CITY OF PUYALLUP Planning Division Approved Site Plan (253) 864-4165 MINIMUM SETBACK REQUIREMENTS Front Yard: 10 ft Rear Yard: 0 ft Interior Side Yard: Left: 0 ft Right: 0 ft Street Side Yard: N/A Zoning District: RM-CORE Permit #: PRMU20240281 Additional Conditions/Comments

**Bradley** Heights **Apartments**

Puyallup,

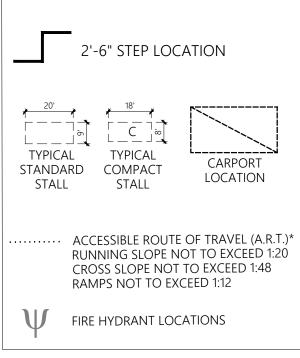
No EV parking calculations included in parking summary. Provide EV parking to meet Section 429 of the 2018 IBC WA Amendment. Page A2 - Site

Incomplete site plan. Please refer to the CoP Site Plan Standards (available to download in the permitting portal). Revise the site plan to include items 1-3 and items A-X of the City's Site Plan Standards. Since the building permit cannot be issued until civil construction permit is issued first and the building plans must match the approved civil plans, please coordinate your final building permit submittal with the approval of the civil permit to avoid redundant or surplus building permit submittals and fees . [SITE PLAN, sheet A2]

> Refer to the PRCNC20240278 corrections and address for all site plans associated with the Bradley Heights Apartments. [SITE PLAN, sheet A2]
